Well Name: POKER LAKE UNIT 20 BD	Well Location: T25S / R30E / SEC 20 / SWSW / 32.10881 / -103.910517	County or Parish/State: EDDY / NM
Well Number: 117H	Type of Well: OIL WELL	Allottee or Tribe Name:
Lease Number: NMLC064894	Unit or CA Name: POKER LAKE UNIT	Unit or CA Number: NMNM71016X
US Well Number:	Operator: XTO PERMIAN OPERATING LLC

Type of Submission: Notice of Intent

Type of Action: APD Change

*Changes approved through engineering via **Sundry 2844202** on 4-12-2025. Any previous COAs not addressed within the updated COAs still apply.*

ACREAGE DEDICATION PLATS

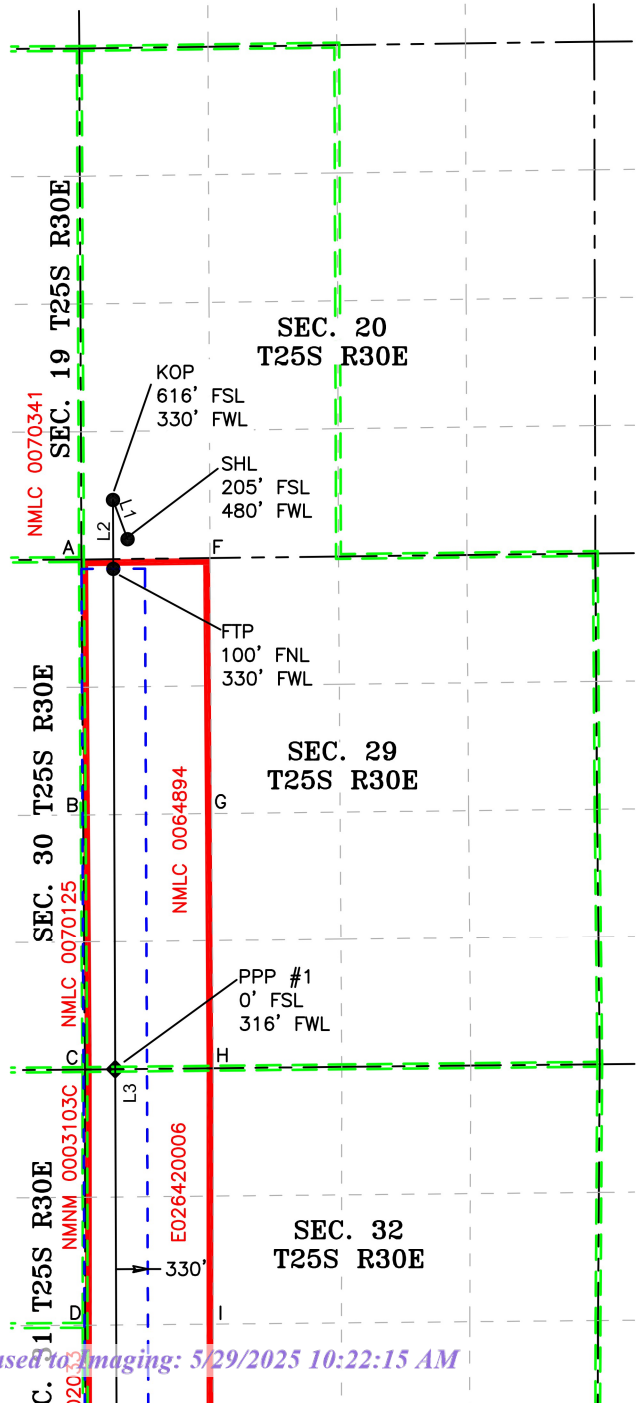
C-102 Submit Electronically Via OCD Permitting	State of New Mexico Energy, Minerals & Natural Resources Department OIL CONSERVATION DIVISION	Revised July 9, 2024	
		Submittal Type:	<input type="checkbox"/> Initial Submittal
			<input checked="" type="checkbox"/> Amended Report
		<input type="checkbox"/> As Drilled

Kick Off Point (KOP)									
UL M	Section 20	Township 25 S	Range 30 E	Lot	Ft. from N/S 616' FSL	Ft. from E/W 330' FWL	Latitude 32.109937	Longitude -103.911001	County EDDY

First Take Point (FTP)									
UL D	Section 29	Township 25 S	Range 30 E	Lot	Ft. from N/S 100' FNL	Ft. from E/W 330' FWL	Latitude 32.107968	Longitude -103.911001	County EDDY

Last Take Point (LTP)									
UL M	Section 32	Township 25 S	Range 30 E	Lot	Ft. from N/S 100' FSL	Ft. from E/W 330' FWL	Latitude 32.079314	Longitude -103.910999	County EDDY
